Groundwater and Wastewater Services File Imaging Project
May 2007

CERTIFICATE OF COMPLETION/OPERATION PERMIT

INSTALLATION, CONSTRUCTION, ALTERATION, AND/OR REPAIR PERMIT

LPP System Design File 4620A

File 4620A

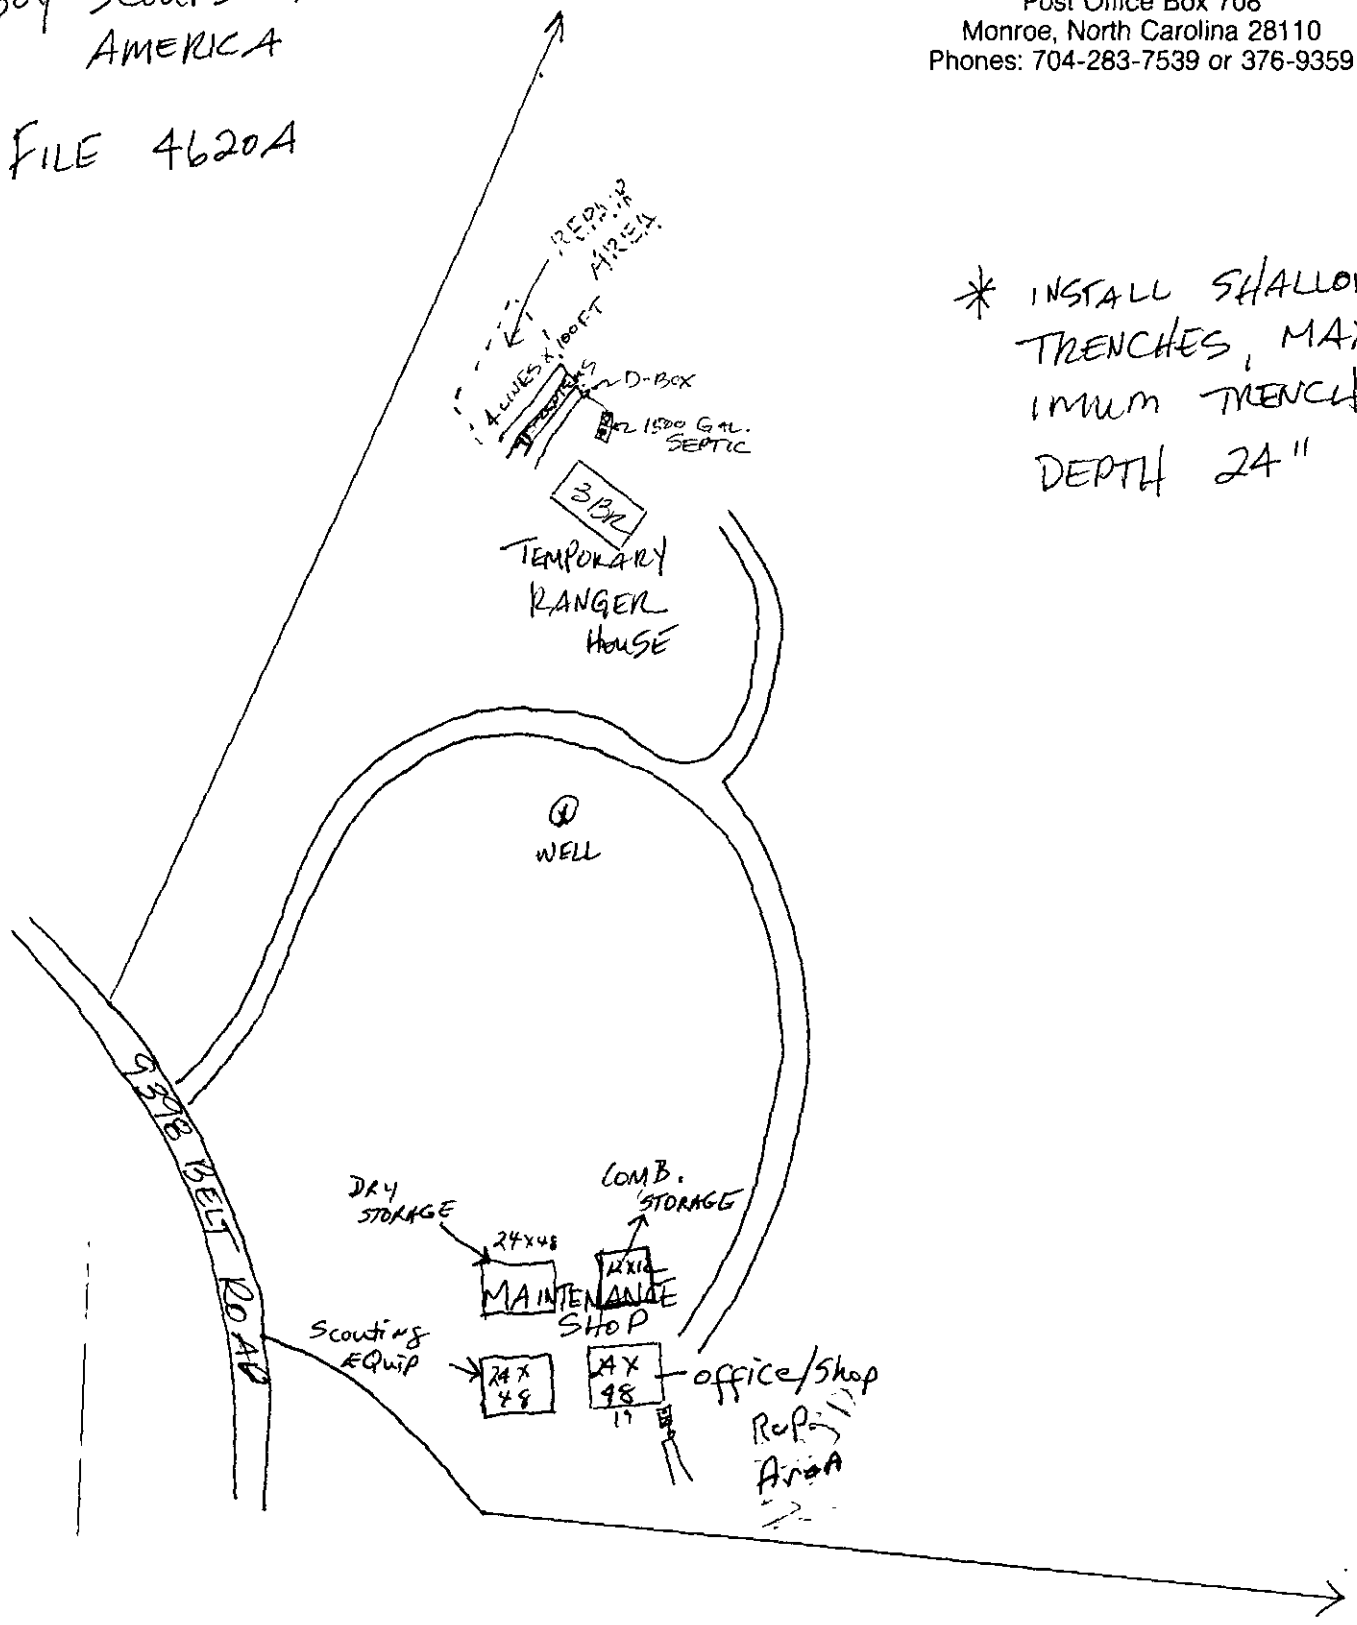
- The well should be located 100 feet or no less than 50 feet away from any part of the sewage disposal system and repair area.
- Water saving plumbing devices and low flush or microflush toilets must be installed when constructing the residence.

* INSTALL SHALLOW TRENCHES, MAXIMUM TRENCH DEPTH 24"

MECKLENBURG COUNTY ENVIRONMENTAL HEALTH
SITE EVALUATION REPORT
SERIAL NUMBER 15271

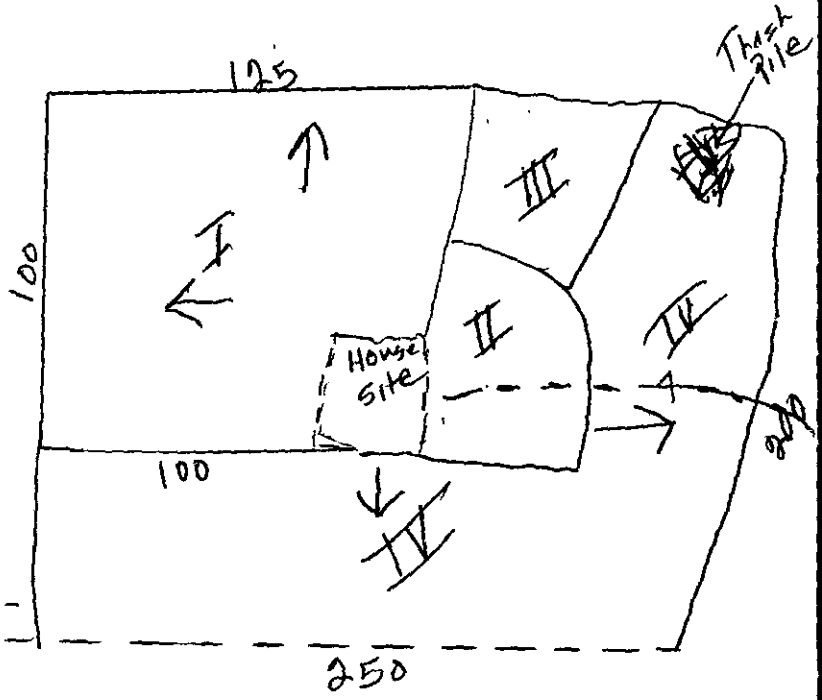
Comments: Caroline Slate Soils. Area I Very good, but Lacks Depth.
